**PROPOSED MODIFICATION OF THE MIXED DEVELOPMENT USE AT NO. 157**  
**REDFERN STREET, REDFERN**  
**MP 09 0039 MOD 1**

To determine a modification request for the mixed development project approval (MP09\_0039 MOD 1).

Figure 2: Western elevation face area.

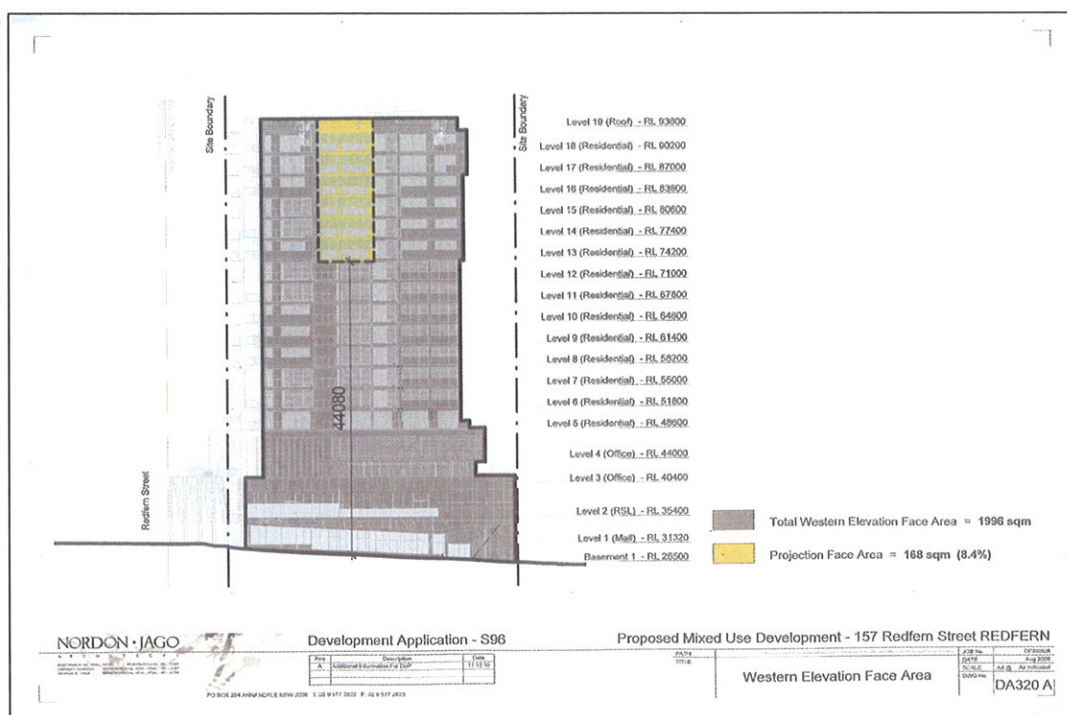
The proponent submits that the modifications proposed involve the following non-compliant reductions in the approved building's setbacks from Gibbons Street at levels 13 to 18:

- the setback of the main wall of the building is to be reduced from a minimum of 3.67m in the area where the balconies are to be enclosed, to 2.585m; and
- the setback of balconies is to be reduced from 2.585m to 0.82m.

The reduced setbacks are to occur only on parts of five (5) levels of the approved building, namely levels 13 to 18, with the underside of level 13 being some 44m above the footpath level in Gibbons Street (western elevation). The area in which the setback is to be reduced is to have an elevational area of 168m<sup>2</sup> in the western elevation, which has an overall area of 1,996m<sup>2</sup>. This represents some 8.4% of the building's western elevation (refer to **Figure 2** and **3**).

The Department is satisfied that, although the setbacks proposed are non-compliant, the setback encroachment at the upper levels 13 to 18 positively contributes the visual horizontal and vertical modulation of the western elevation without any detrimental impact on the streetscape or adjoining buildings.
